SUNDRY NOTICES AND REPORTS ON WELLS

Central Carbin Queen Unit #107

30-025-36869

Permanent Abandonment of Federal Wells
Conditions of Approval

✓ OXY USA Inc. - Proposed
Central Corbin Queen Unit #107
API No. 30-025-36869

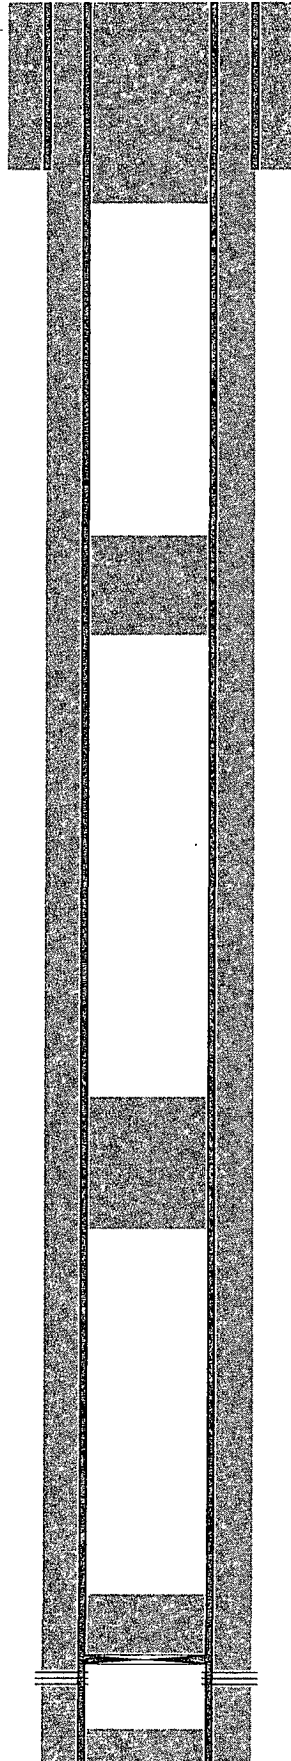
1. RIH & Set CIBP @ 4165', M&P 25sx cmt to 4015'
 2. M&P 40sx cmt @ 3075-2800' WOC-Tag
 3. M&P 25sx cmt @ 1575-1425' WOC-Tag
 4. M&P 70sx cmt @ 461' to Surface
- 10# MLF between plugs

70sx @ 461'-Surface

25sx @ 1575-1425' WOC-Tag

40sx @ 3075-2800' WOC-Tag

CIBP @ 4165' w/ 25sx to 4015'

SEE ATTACHED FOR
CONDITIONS OF APPROVAL
